MEMORANDUM FOR: RECORD

SUBJECT: DETERMINATION ON THE SUITABILITY OF PROPOSED DREDGED MATERIAL FROM THE PORT OF SEATTLE T-91 IN SMITH COVE, SEATTLE, WASHINGTON (FILE # 200601091) EVALUATED UNDER SECTION 404 OF THE CLEAN WATER ACT FOR OPEN-WATER DISPOSAL AT THE ELLIOTT BAY DMMP DISPOSAL SITE.

Figure 2
Actual Sample Locations
Terminal 91
Port of Seattle

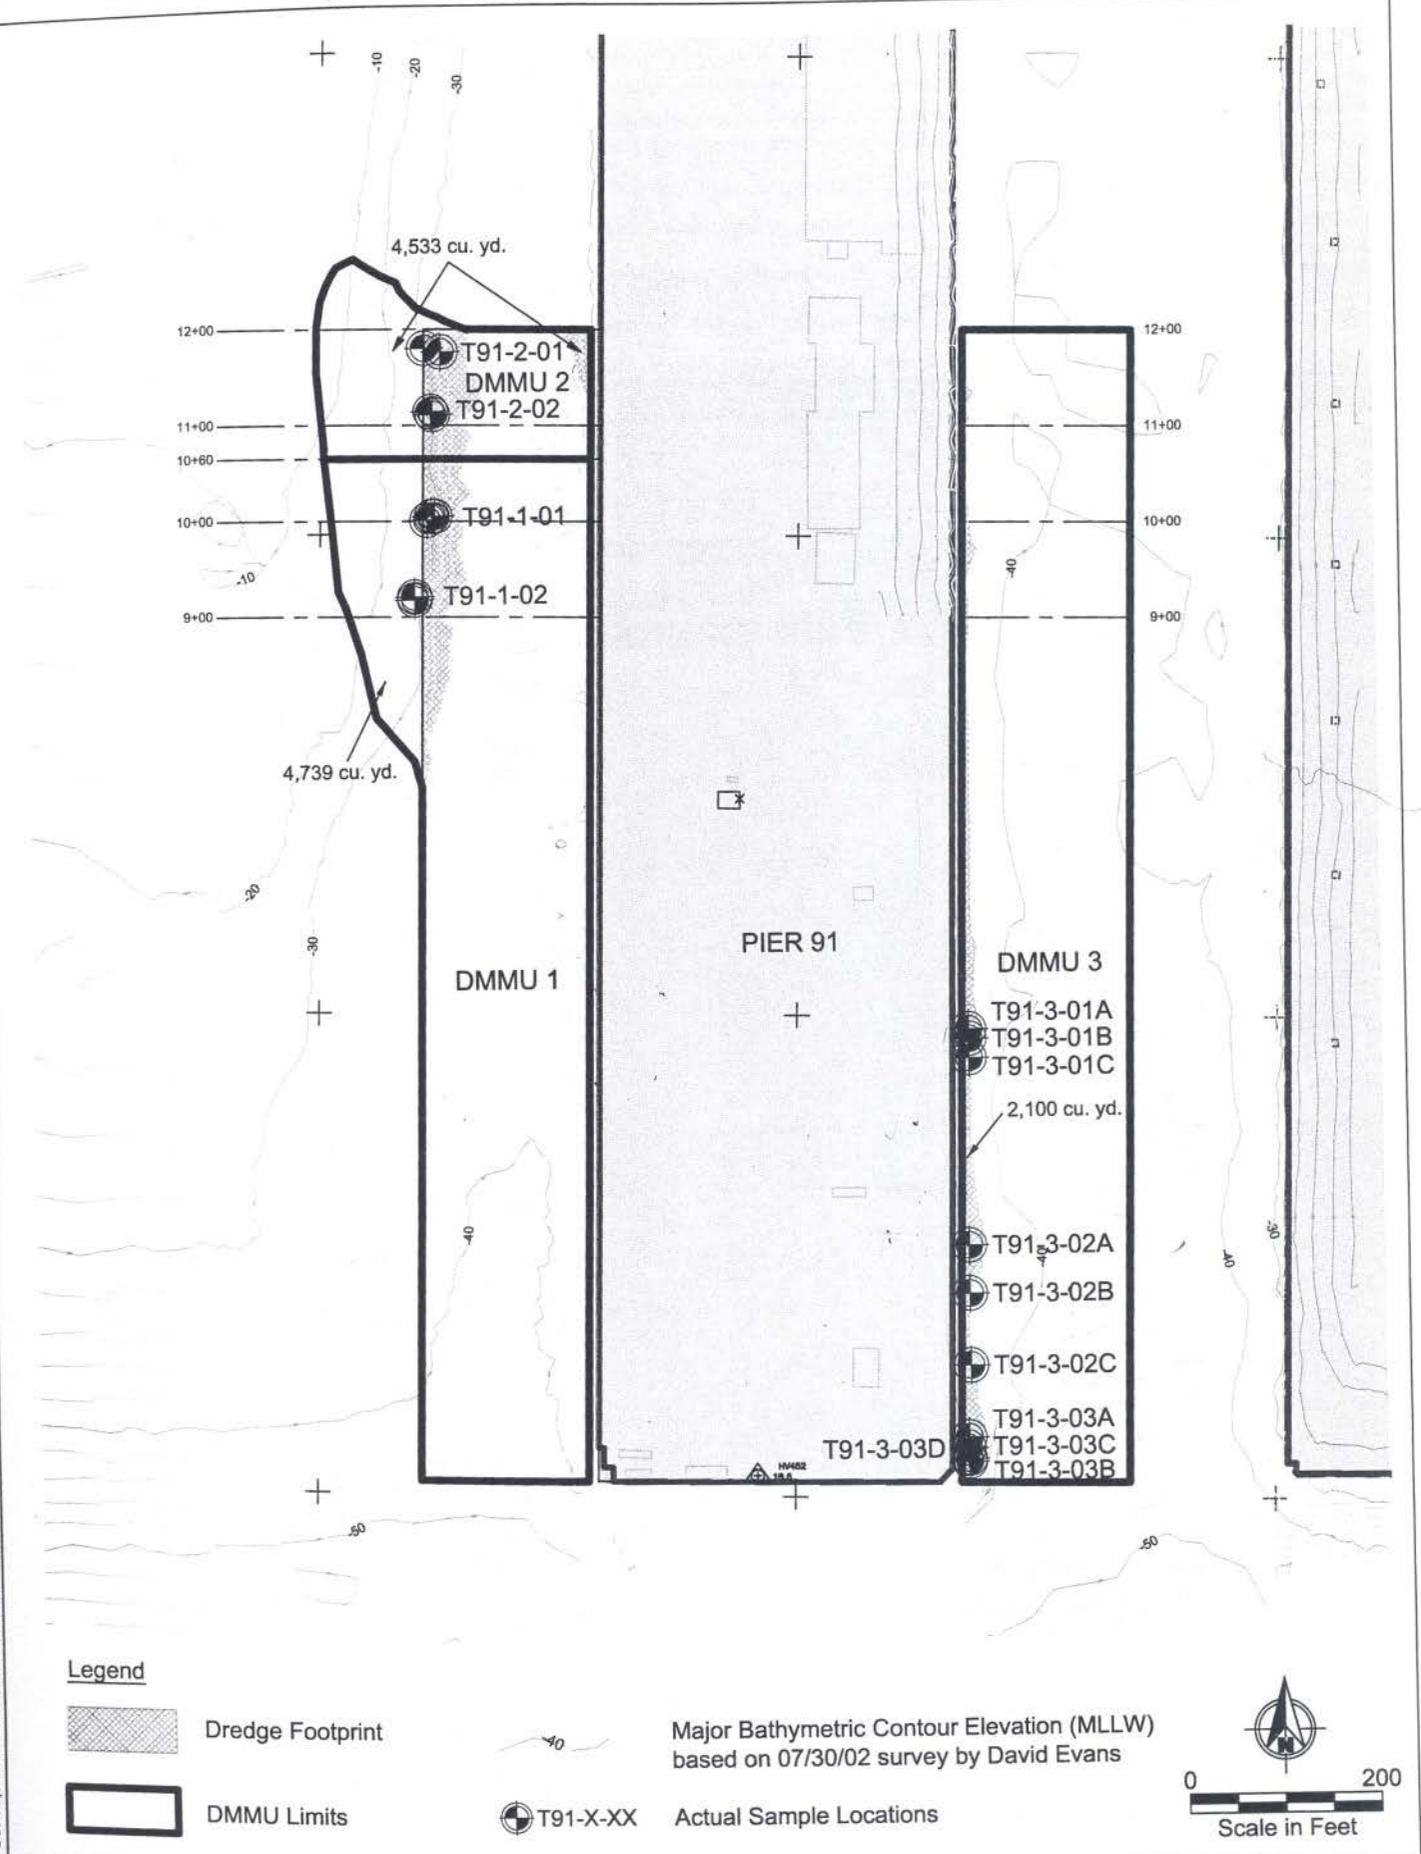
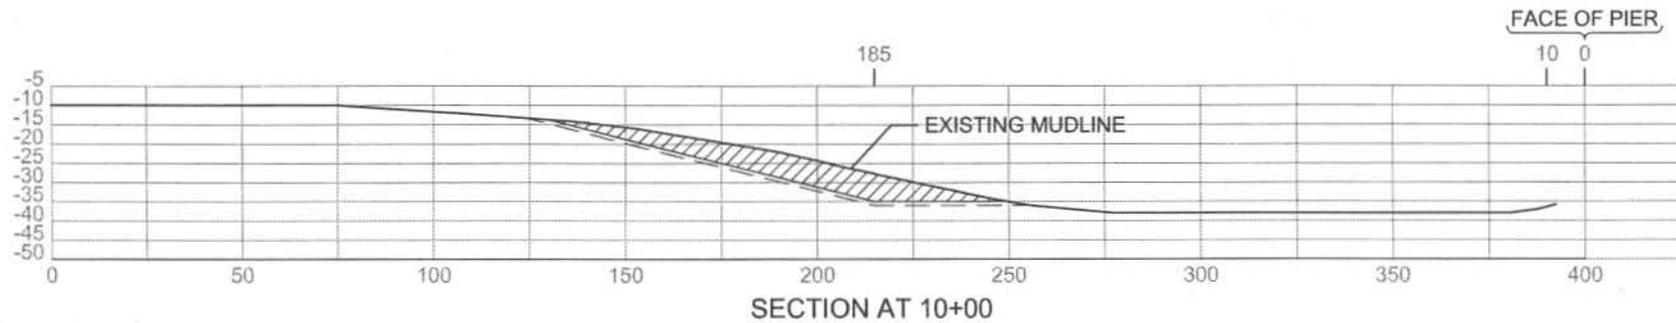
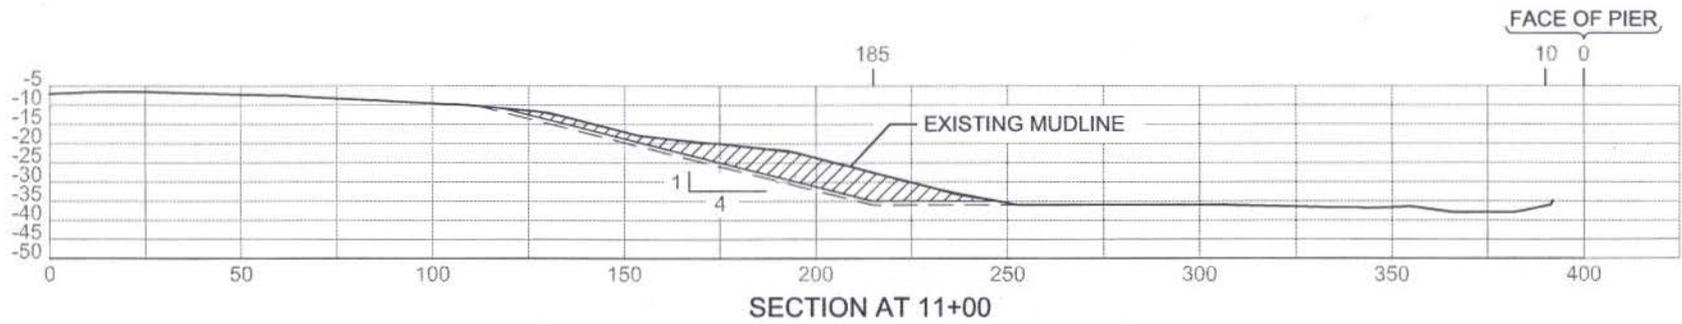
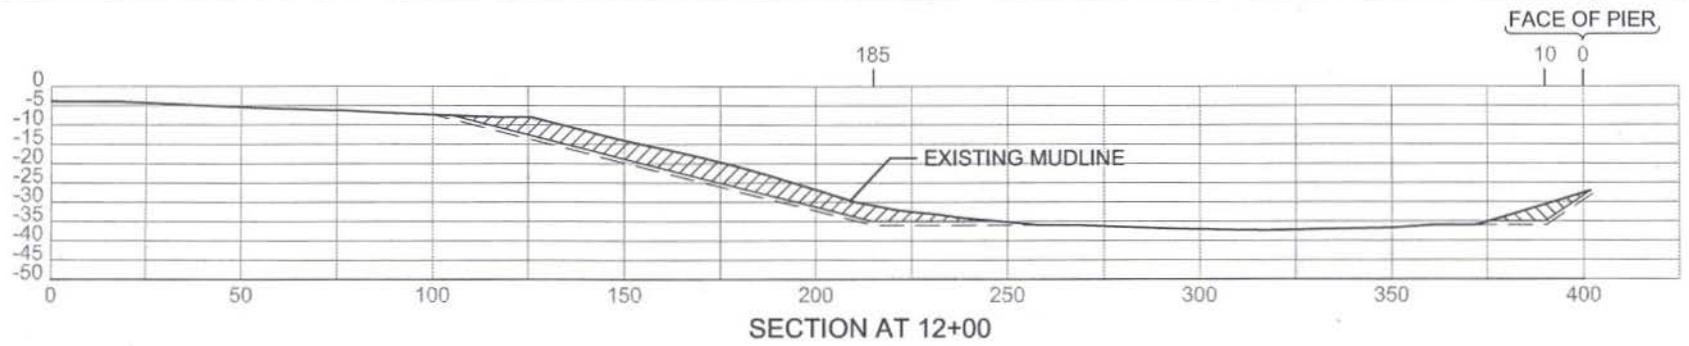
3. **Sampling.** Figure 1 shows the general vicinity map of the project area, whereas Figures 2 and 3 depict bathymetry, cross sections, and the sampling locations of the three DMMU's.

Sampling of Pier 91 took place on June 7 and 8, 2006. In general, the agencies' Sampling and Analysis Plan (SAP) was followed. Refusal was encountered in almost all cores collected in DMMU 1, and only one core used in the composite was collected to a depth of -37 feet MLLW (comprising a design depth of -35 feet MLLW, 1 foot of allowable overdredge, plus 1 foot for collection of a Z-layer). The other core only reached a depth of -30.2 feet MLLW. The maximum depth of sediment samples collected from DMMU 2 was -34.9 feet MLLW. Consequently no z-sample was collected for DMMU 2. Sediment samples were not collected in DMMU 3 due to hard rocky substrate or riprap that refused penetration of the coring device on all attempts.

Sampling at Pier 91 required two cores from DMMU-1 and DMMU-2 although six cores were collected from DMMU-1 and five from DMMU-2. Only two cores from each DMMU were composited to form a single sample.
